Change Notice

IS Series

Discontinuation of IS Part Numbers & Replaced with Wide View Models

Alternate Wide View IS Switches

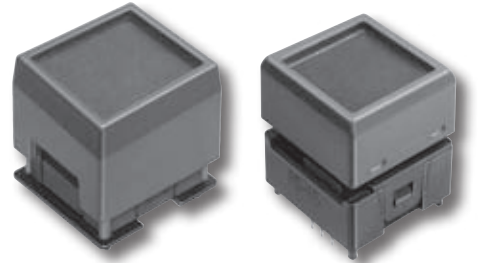
Some of the IS Series part numbers will be discontinued and replaced with alternate part numbers. These include all of the LCD standard 64 x 32 and 36 x 24 Pushbuttons and Displays. The alternate part numbers feature wider viewing areas. The tables below show the effected part numbers and the alternate IS models.

* These IS Part Numbers do not have a direct alternate. The recommended Alternate PNs may require a change to the PCB layout, resistors or firmware. Call NKK Switches for more details or assistance.
